2.5 Geology, Seismology, and Geotechnical Engineering

In Section 2.5, “Geology, Seismology and Geotechnical Engineering,” of the site safety evaluation report (SSAR), the applicant, System Energy Resources, Inc. (SERI), provided a detailed description of the geological, seismological, and geotechnical engineering properties of the early site permit (ESP) site. In this safety evaluation report (SER), Section 2.5.1, “Regional Geology,” describes basic geological and seismological data, especially the data published since 1986 for the area within a 200-mile radius of the ESP site, and presents updated seismic sources. Section 2.5.2, “Vibratory Ground Motion,” evaluates the vibratory ground motion for the ESP site and analyzes the safe-shutdown earthquake (SSE) ground motion. Section 2.5.3, “Surface Faulting,” describes the potential for surface faulting at or near the surface of the ESP site. Section 2.5.4, “Stability of Subsurface Materials and Foundations,” presents the results of site geotechnical investigations and discusses the stability of subsurface materials and foundations. Section 2.5.5, “Stability of Slopes,” defers the analyses for slope stability at the site and dam perf

Figure 2.5.2-2 (SSAR 2.5-58)

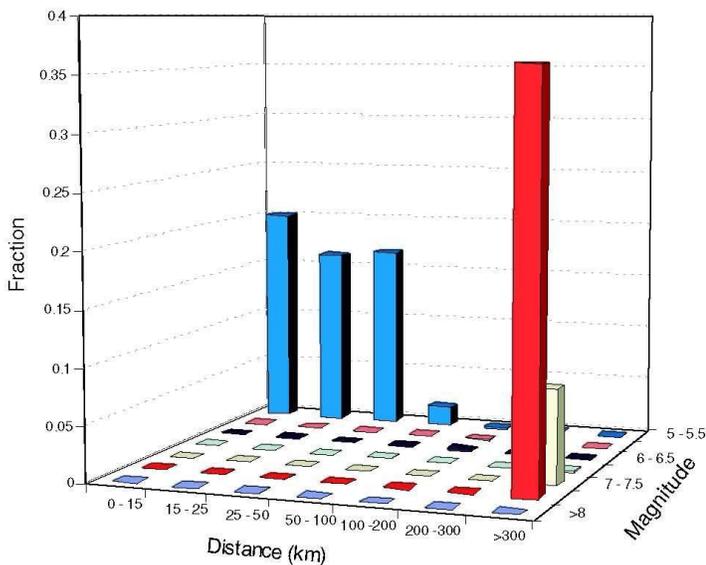
In RAI 2.5.2-9, the staff asked the applicant to explain why the SRSZ, with a magnitude as large as 6.0–7.0 and a distance at 81–206 miles, makes no contribution to the deaggregation results. In its response, the applicant stated the following:

In RAI 2.5.2-9, the staff asked the applicant to explain why the magnitude and distance bin corresponding to the SRSZ makes no contribution to the deaggregation result, although the SRSZ maximum earthquake magnitude is as large as 6.0–7.0 and has a distance of 81–206 miles from the ESP site. The applicant stated that the overall rate of earthquake occurrence (M_w greater than 5) at these distances for the SRSZ was too low to contribute to the 10^{-5} median hazards. However, in SSAR Section 2.5.2.1.3 and its response to RAI 2.5.1-3, the applicant stated that the activity of the SRSZ has a probability of 0.5 for its existence, which means the SRSZ has a 50 percent chance of producing an earthquake with a magnitude range between 6.0–7.0. The applicant also assigned three different return periods (388, 1725, and 3505 years) to the characteristic SRSZ earthquake model (probability of 0.6) based on paleoliquefaction data, in contrast to the longer recurrence times based on slip rate (probability of 0.4). Even the earthquake with a 3505-yr return period should have repeated about 30 times in the 100,000-yr time span that is associated with a 10^{-5} probability of exceedance. In this bimodal distribution, as the applicant stated in a previous RAI, the reason the magnitude and distance bin corresponding to the SRSZ did not have any contribution to the hazard is not understood. The staff concludes that this RAI remains unexplained. This is **Open Item 2.5-3**.

The purpose of the magnitude-distance deaggregation is to provide a measure of the relative contribution of events (of different magnitude-distance pairs) to the total hazard. The deaggregation graphs in the SSAR show the relative contribution of earthquakes to the 10^{-5} median. The fact that events associated with the Saline River source (and all sources in this distance range) do not contribute to the 10^{-5} median hazard for the Grand Gulf site is primarily due to the fact that the overall rate of earthquake occurrences ($M_w > 5$) at these distances is extremely low. Further, the rate of occurrence of earthquakes of magnitude 6.0–7.0 is thus much lower. The result is that the estimated ground motion hazard at the Grand Gulf site is extremely low and, in a relative sense, makes little or no contribution to the 10^{-5} median hazard.

Figure 2.5.2-3 (SSAR Figure 2.5-59)

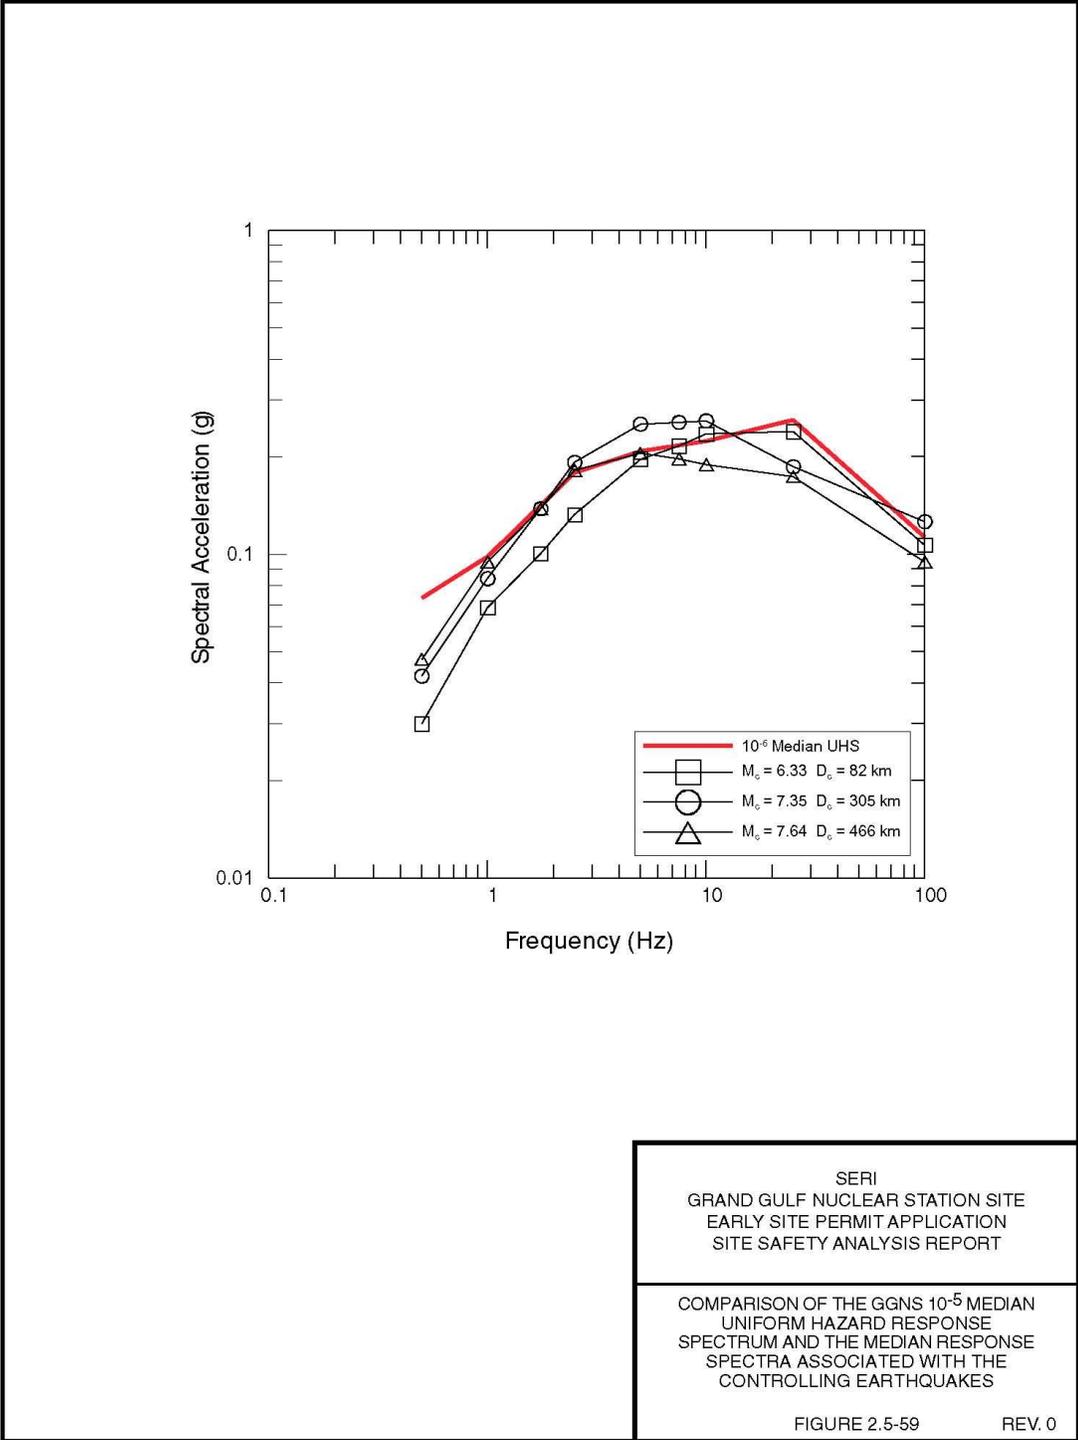
In RAI 2.5. 2-10, the staff asked the applicant to provide an explanation as to why the magnitude-distance bin, including the controlling earthquake, does not contribute to the high-frequency deaggregation. In its response, the applicant stated that the controlling earthquake for a given frequency range is the mean magnitude and mean distance of the deaggregation distribution. If deaggregation is multimodal or bimodal as in the Grand Gulf case, the resulting mean may not correspond to the magnitude values that are actually defined in the distribution.

The applicant's response to RAI 2.5.2-10 adequately explained why the high-frequency deaggregation graph shows no contribution from the magnitude-distance bin that contains the controlling earthquake.

(Figures 2.5.4-1 and 2.5.4-2) (SSAR Figures 2.5-30 and 31)

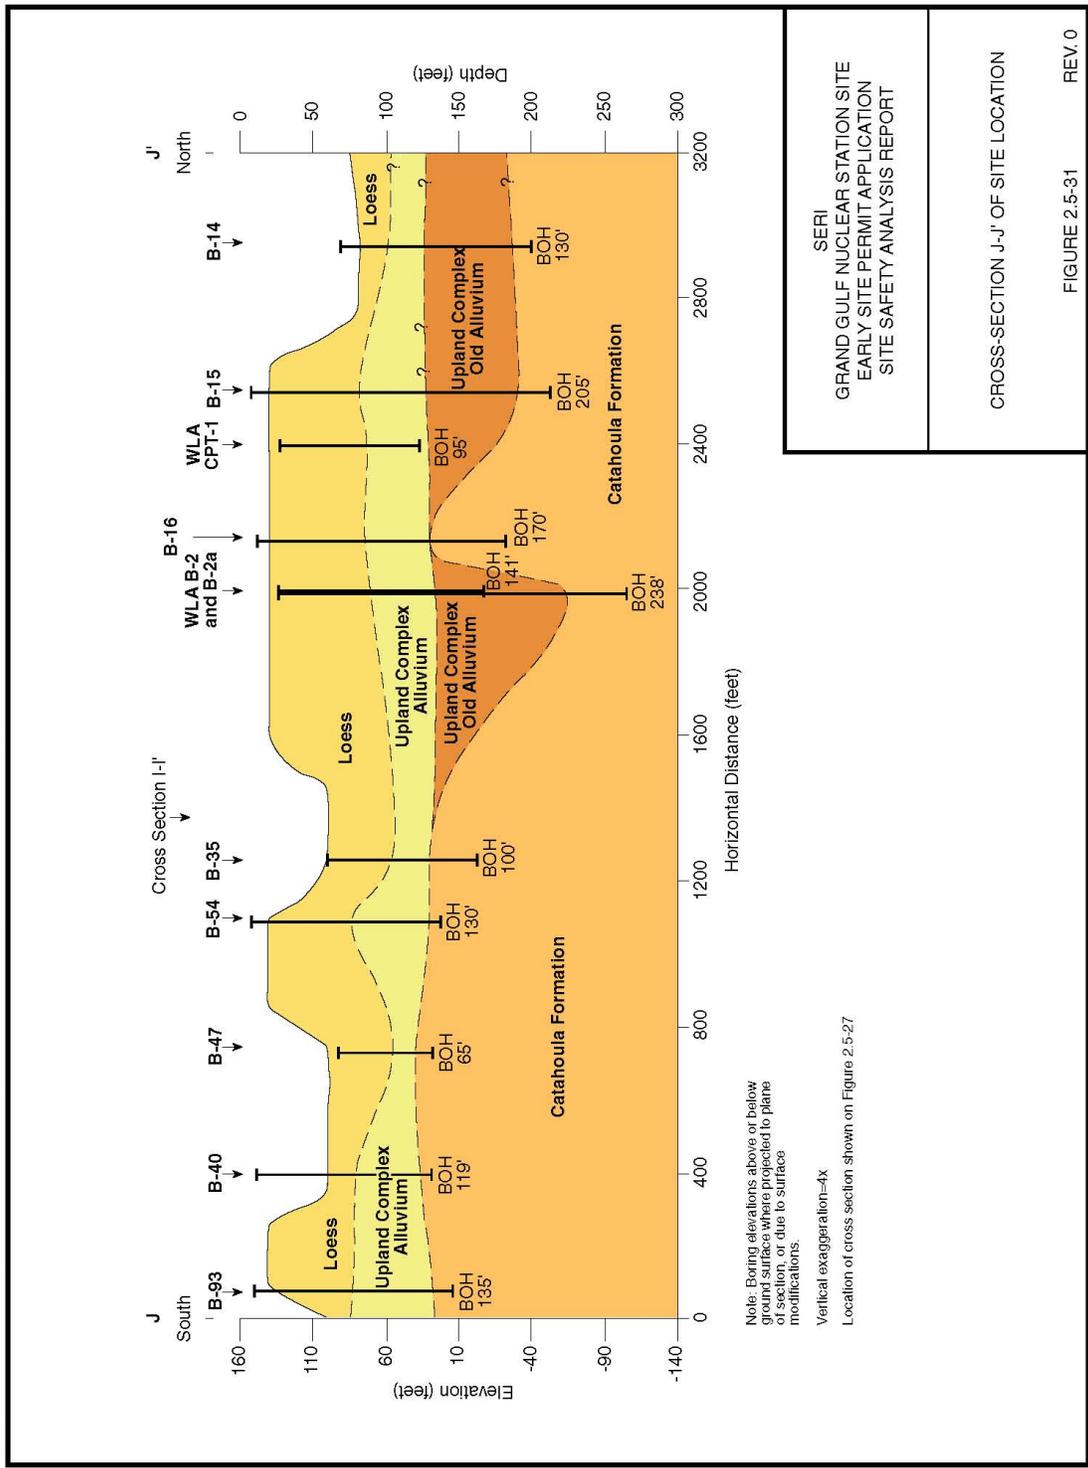
In SSAR Section 2.5.4.1.2, the applicant provided soil profiles developed for the ESP site, as shown in Figures 2.5.4-1 and 2.5.4-2. The maximum depth of these borings investigated during this program extends to about 240 feet. In RAI 2.5.4-3, the staff asked the applicant to provide the number and maximum depth of the borings that were used to characterize the ESP site area.

Presuming that these borings are also relatively shallow and that the site profile used in SSAR Section 2.5.2.3 extends thousands of feet deep into the hard rocks referred to in the EPRI-SOG ground motion attenuation relationships, the staff also asked the applicant to present additional information that allows for the characterization of the ESP site materials from a corresponding depth. In its response, the applicant explained that it characterized the ESP site by two individual borings, one composite boring, and four CPT soundings for the ESP site investigation program. The applicant distributed these borings and CPT soundings throughout the ESP site. The revised map (Figure 2.5.4-3) shows a circular PPBA that supersedes the previous polygonal proposed site location perimeter and indicates the approximate locations of the available UFSAR borings within the ESP area. The depths of the new ESP borings range between 142 and 238 feet below the ground surface while the depths of the CPT soundings range between 79 and 95 feet below the ground surface. The applicant augmented the ESP explorations with data from 20 previous borings performed for the UFSAR that fall within or adjacent to the ESP PPBA. The UFSAR borings extend to depths of between 81 and 300 feet below the ground surface. The combined coverage of the ESP and UFSAR borings provides sampling across the entire PPBA at 200- to 600-foot spacing and down to a depth of 300 feet. One of the ESP borings and about four to six of the UFSAR borings extend into the dense clay to claystone that the applicant defined as the Miocene Catahoula formation. Two of these borings include interval core sampling of the Catahoula formation. Revised SSAR Figure 2.5-69 integrates the ESP and the UFSAR explorations and indicates a good control to a depth of about 250 feet below the ground surface.
